Modification of Consent (Mod 2) Response To Submissions State significant development SSD 7628

Modification 2

MOOREBANK PRECINCT EAST STAGE 2 (SSD 7628)

Report No 1909002005.1

Figure 3-3 Definition of riparian corridor (Source: NSW Office of Water Controlled Activities on Waterfront Land - Guidelines for riparian corridors on waterfront land, NSW Office of Water, July 2012, p.2)

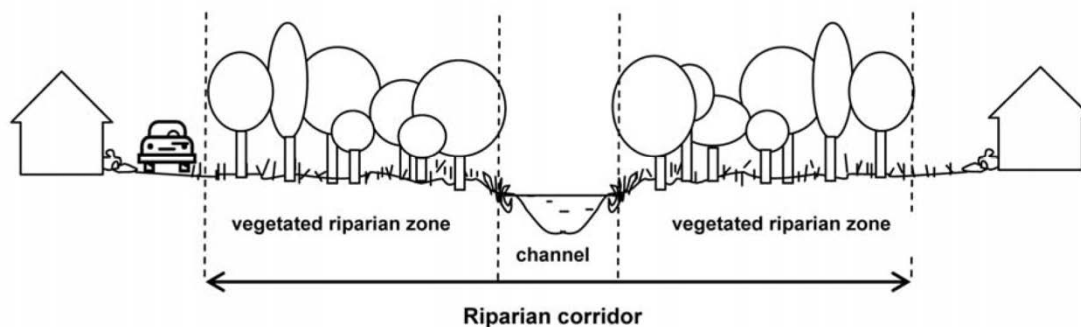
The LCC subsequently provided an additional submission on 27 August 2019 and provided comment in respect of the proximity of works to the riparian corridor of Anzac Creek and consideration relating to implementation and maintenance of safety measures and landscaping in respect of OSD 9.

The proposed footprint extension under the modification application does not therefore encroach on the riparian corridor of Anzac Creek.
